# PRE-APPLICATION CONFERENCE NOTES Peterson Subdivision (2023-025-PAC)

Meeting conducted on Wednesday, July 26, 2023–2:00 P.M.

The applicant is proposing to subdivide the site to create 47 fee simple lots with 31 single-family detached residences and 16 single-family attached 2-plex residences. The site is designated Urban Residential (UR) on the City's Comprehensive Plan map and is zoned Medium Density Residential (MDR-16) on the City's adopted zoning map.

Figure 2: Severe Erosion Hazard Areas (in brown)

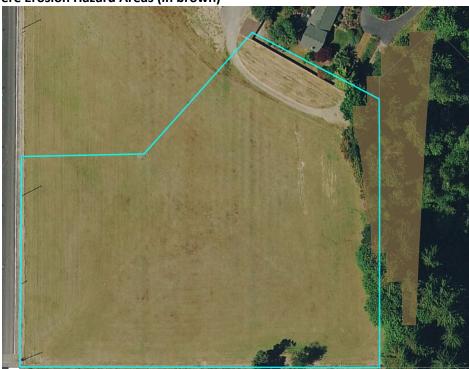
Because onsite slopes are steep with areas of severe erosion hazards and potential instability as shown in Figures 2 and 3, the applicant is required to provide a geotechnical report assessing the potential for landslide hazards. If a landslide hazard exists, the applicant's report should address LCMC 18.300.090(4) including alterations to geologically hazardous areas (b) general design standards for landslide and erosion hazard areas (c) and design standards for landslide hazards (d).
